**CITY OF POMPANO BEACH  
DRC COMMENT RESPONSES**

**CASE NUMBER:** PZ23-12000046

**Request:** Major Site Plan

**Project Location:** 31 NE 22 Avenue

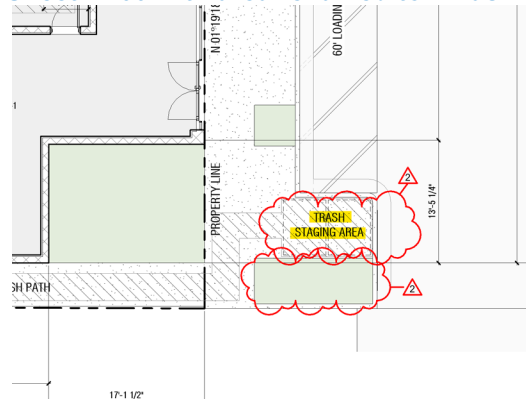
2. Make sure the site plan and the ground floor plan both show the poured concrete pad for the staging area. Currently, only the ground floor plan shows it.

**RESPONSE:** The poured concrete pad has been added.
